Cc: Artur Breidt; Marc Van Impe
Subject: GRVA SIG EMB Expert Group on Energy meeting minutes 16082023
Attachments: 2023-08-16_EBSIG_Report Sub Group Energy_to SIG-EMB.pptx

4th Meeting SIG EMB Expert Group on Energy

Date: 16th of August 2023

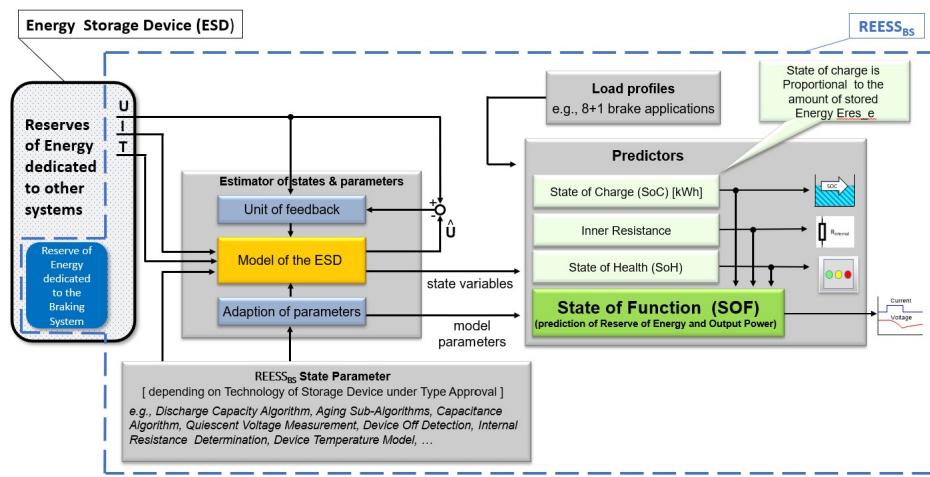
1. Rules of Compliance
 - Arlina Benson (VDA) introduced the rules of compliance to be respected in the meeting.
2. Adoption of the Meeting Minutes of the EMB Sub-Group Meeting from August 8th
 - The meeting minutes of the last meeting are approved.
3. Review **and Adoption** of the Report to EBSIG on the Energy Questions
 - Heiner provides a summary of the presentation which was sent to all participants ahead of time: *"2023-08-09_Sub Group Energy_working material_4th session_EMB Industry Meeting (230810)_V01"*, as well as pointing out all changes made
 - Review of the tasks given by GRVA SIG on the Electromechanical Braking:

Provide confidence that technology is able to do the following:

- 1) Measure and/or monitor in real time the energy available in the reserve in all operating conditions and over the lifetime (high temperatures, ageing, ...).
- 2) Compare that measured value with the known threshold value required to meet the specific performances required by the regulations. Note: The known value means the value identified by the manufacturer to fulfil the specific requirements of the regulation.

- 3) To be able to generate the warning to the driver in real time in accordance with the known threshold value.

- SoF – Jonas Stueble made small changes of the presentation, slide 4:

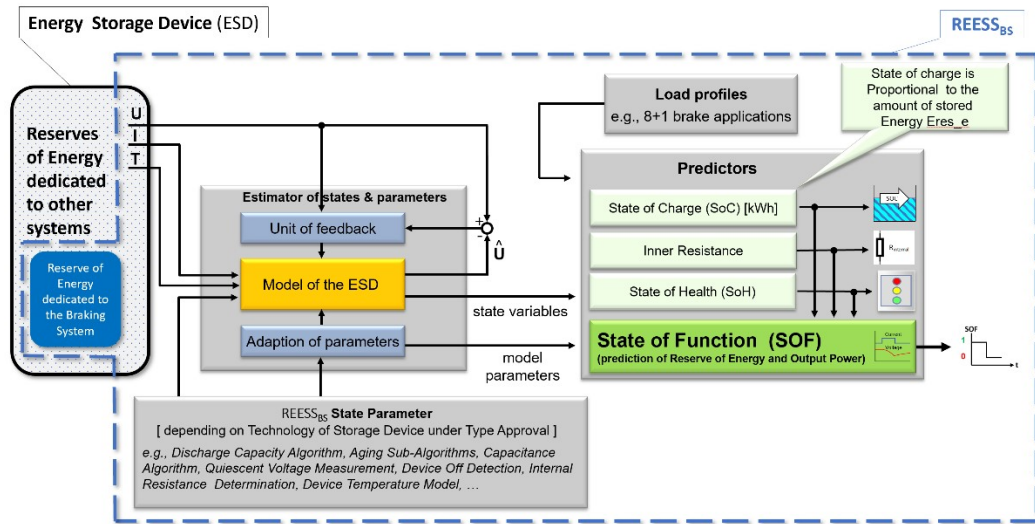
Rechargeable Electrical Energy Storage System for Braking Systems (REESS_{BS})

- The Output power is explained by a constant current to the actuators, provided by a dedicated voltage.
- The SoF is reported as a binary value to the braking system. The function of the battery shows a “yes” or “no”. This is answered by the current and voltage output.

- The Expert Group adopted the Presentation inkl. The Changes Jonas Stueble made on Slide 4.
- This presentation will be sent to the Chair, Bernie Frost, to be uploaded to the wiki-page, as well as being subject to the upcoming SIG-02 meeting.
- The newly changed presentation will be sent to the Expert Group, along with the meeting minutes.
- **As there will be no further online-meetings for the SIG EMB Expert Group on Energy: Arlina proposed that the meeting minutes will be seen as approved by the Expert Group, shall there be no remarks made by Monday, 21st August 2023, 5pm CET.**
